<b>APPLICATION FOR PERMIT TO DRILL</b>				5. MINERAL LEASE NO: <b>ML-22794</b>	6. SURFACE: State
1A. TYPE OF WORK:    DRILL <input checked="" type="checkbox"/> REENTER <input type="checkbox"/> DEEPEN <input type="checkbox"/>				7. IF INDIAN, ALLOTTEE OR TRIBE NAME:

2. NAME OF OPERATOR: <b>KERR McGEE OIL &amp; GAS ONSHORE L.P.</b>				9. WELL NAME and NUMBER: <b>STATE 1021-31P</b>	
3. ADDRESS OF OPERATOR: <b>1368 S 1200 E</b> CITY <b>VERNAL</b> STATE <b>UT</b> ZIP <b>84078</b>			PHONE NUMBER: <b>(435) 781-7024</b>	10. FIELD AND POOL, OR WILDCAT: <b>NATURAL BUTTES</b>

**STATE 1021-31P  
SE/SE SEC. 31, T10S, R21E  
UINTAH COUNTY, UTAH  
ML-22794**

An onsite was conducted on 4/5/07 with the Division of Oil, Gas and Mining Representative and SITLA Representative. It was decided to change the proposed pipeline from a 4" pipeline approximately 1,037 +/- to a 4" pipeline approximately 2,000' +/- and a 6" pipeline approximately 950' +/-.

SCALE: 1"=2000' DRAWN BY: B.C. REVISED: 04-13-07C.P.

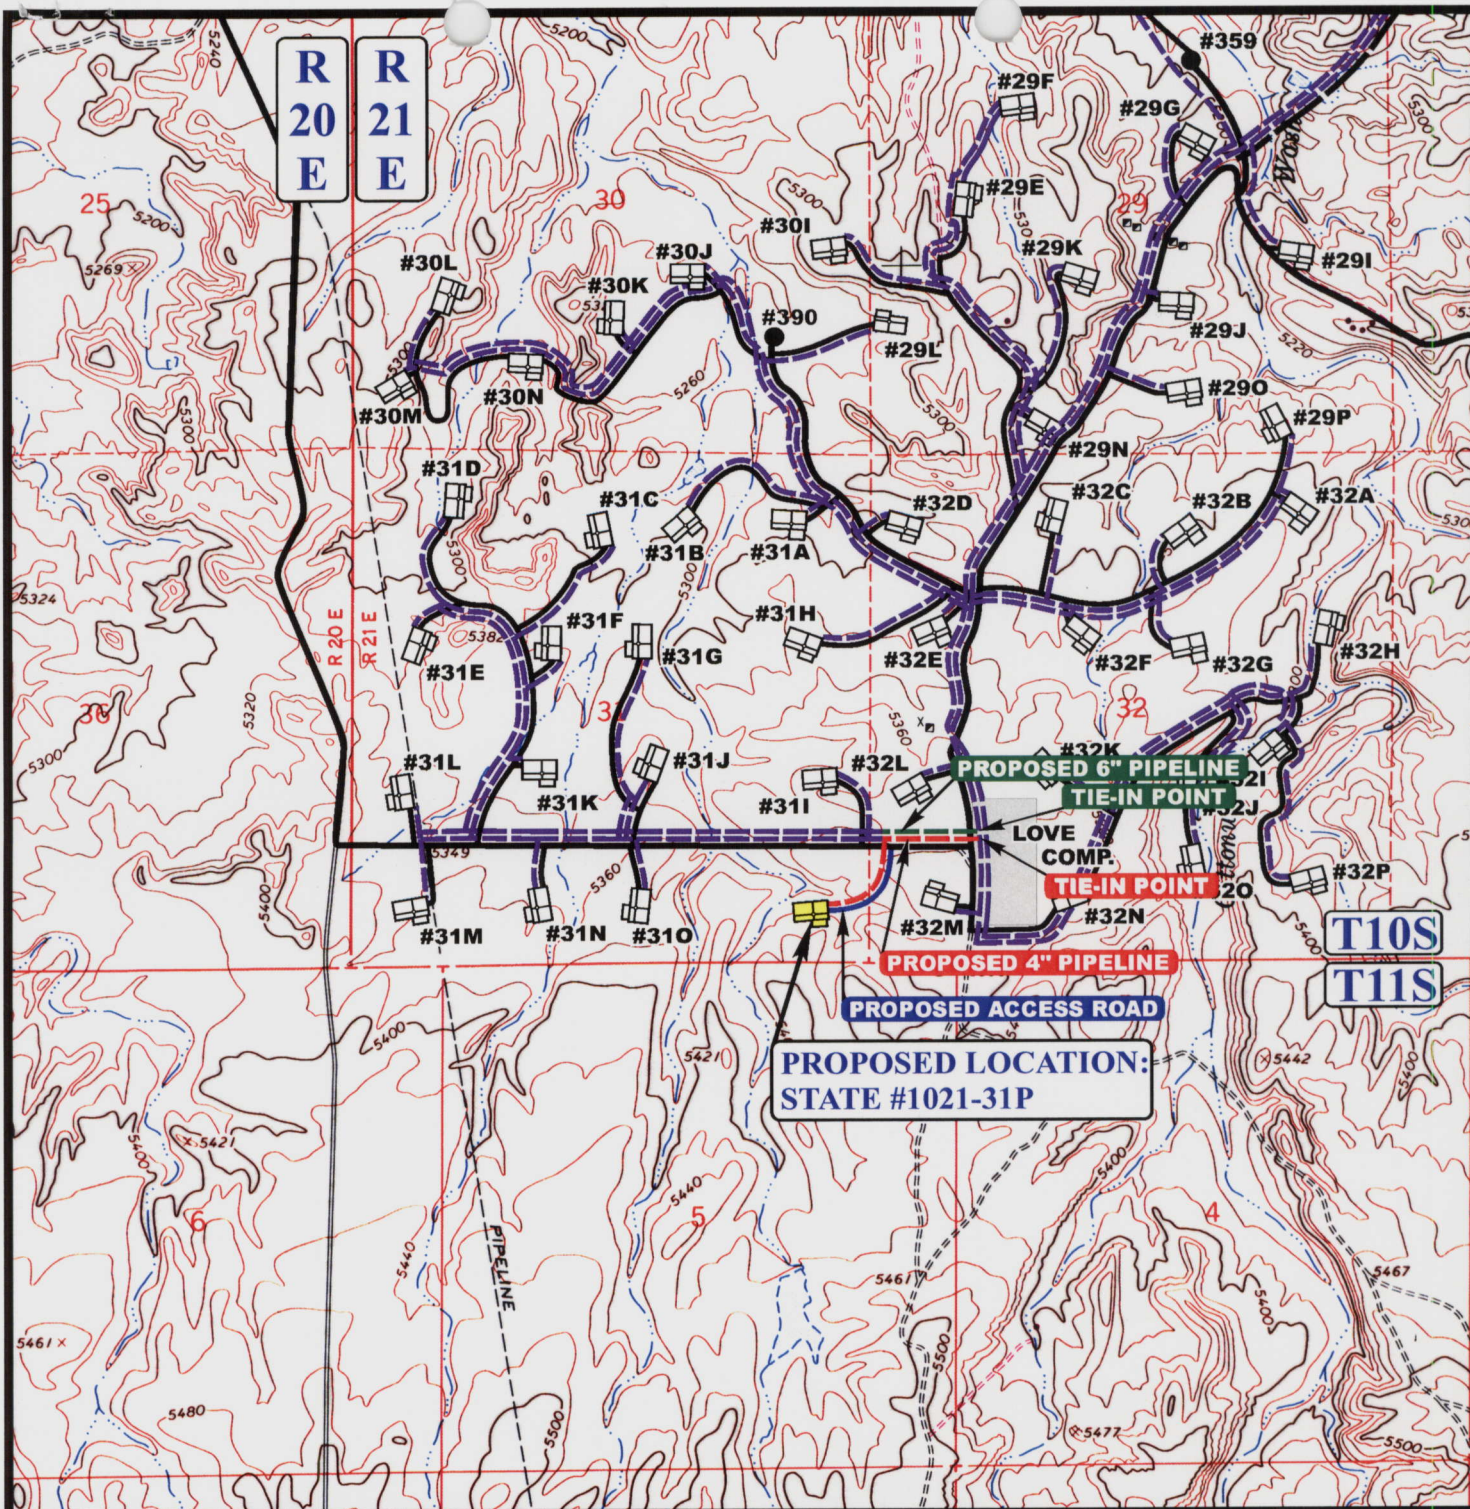
Please refer to the attached Topo D.
